Office Action Summary

10/728,449

PLANEY, WILLIAM

DETAILED ACTION

FIGURE 4

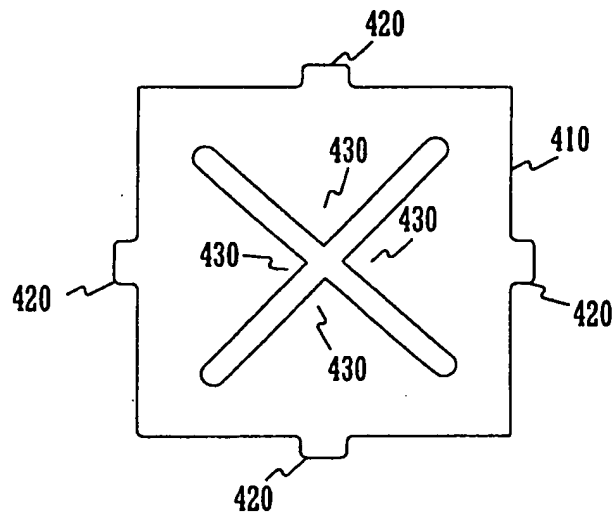
However, figure 4 of Admission illustrates an X-lead frame with four angular tabs 430.

It would have been obvious to one of ordinary skill in the art at the time of the invention was made to replace lead frame 10 of Dunaway with the X-lead frame of the Admission, in order to provide conductive elements for use in interconnecting the lead frame with one of the other electronic device (it is noticed that in col. 5, lines 5 - 10, Dunaway et al. teach that "it is appreciated that lead-frames are variously constructed and shaped").
